Project Name	Great Oak School
Fabby	-
Sketch. No.	25(Page 1 of 2)
RFI.No.

PROJECT OWNER: -
PROJECT DESCRIPTION: GREAT OAKS LEGACY CHARTER SCHOOL
PROJECT ADDRESS: NEWARK, NJ, 07102
CONTRACTOR: -
DRAWN BY: SSV DATE: 11/14/2025 PROJ. NO. 2510 REV # B
CHECKED BY: ASK DATE: 11/14/2025 DWG NO. E112
DWG DESCRIPTION: SECTIONS & DETAILS

Project Name	Great Oak School
Fabby	-
Sketch. No.	25(Page 2 of 2)
RFI.No.

SECTION 2B - 2B

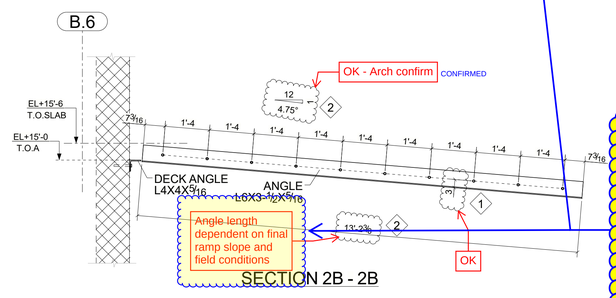
Q.2
The angle length depends on the field conditions. Therefore, we will provide the angle with an extra one foot (one end)and include a note in the drawings to cut to suit in the field. Please advise if this is acceptable, or if we need to wait for the field measurement."

Note:
We will follow typical approach for level 3. Refer to page 2 markup for reference.

no the second level has a bump out 6" on each side of the wall in both location.

The 3rd level does not. Therefore the beams at the 3rd level must be 6" longer.

SECTION 2C - 2C

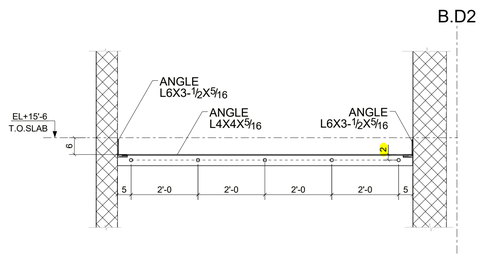
Q.1
As per the clouded notes Clouded dimensions pending GC review and comments to proceed to release associated steels for fabrication.

However if required we can provide the steels **with an extra 1'-0"(6" ether end of the angle or Beam) and include a note to cut to suit in field conditions**. Please advise if this is acceptable."

Note:
We will follow typical approach for level 3. Refer to page 2 markup for reference.

SECTION 2E - 2E
(REF.DWG: 9/S-201)

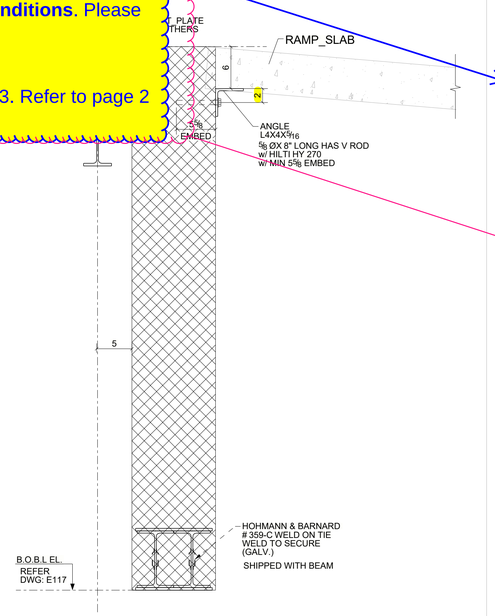
MARKED DIMENSION NEED TO BE FIELD VERIFIED FOR FRAMING PURPOSE MATCHING FIELD CONDITIONS,PENDING SURVEY INFORMATION TO PROCEED.

SECTION 5F - 5F
(REF.DWG: 10/S-201)

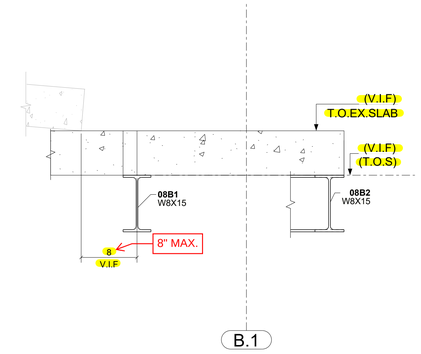
Q.4
Refer to page 1(Q.2) markup for similar question.

Q.3
Refer to page 1(Q.1) markup for similar question.

SECTION 5E - 5E
(REF.DWG: 9/S-201)

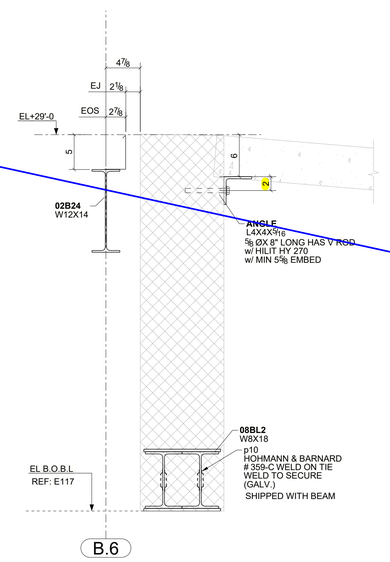
MARKED DIMENSION NEED TO BE FIELD VERIFIED FOR FRAMING PURPOSE MATCHING FIELD CONDITIONS,PENDING SURVEY INFORMATION TO PROCEED.
